## Product Change Notice (PCN)

**PCN Number:** PCN-0451156R-01

**Product(s) Affected:** PJ-039A, PJ-039B, PJ-039AH, PJ-039BH

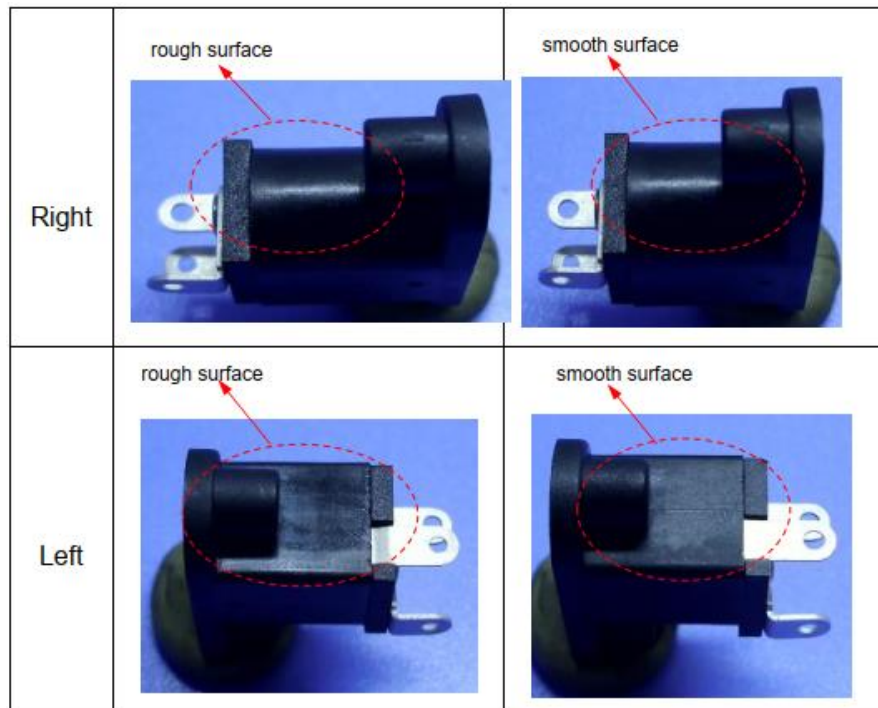
**Description of Change:** Thickness of pin 2 changed from 0.2mm to 0.25mm. Aesthetic changes as shown in below comparisons:

Back	<p>cave marking location</p>  <p>smaller</p> <p>cave marking location</p>	<p>cave marking location</p>  <p>thicker</p> <p>cave marking location</p>
Top	<p>with injection mark</p>  <p>thickness of pin#2 is 0.2mm</p>	<p>without injection mark</p>  <p>thickness of pin#2 is 0.25mm</p>
Bottom	<p>without injection mark</p> 	<p>with injection mark</p>
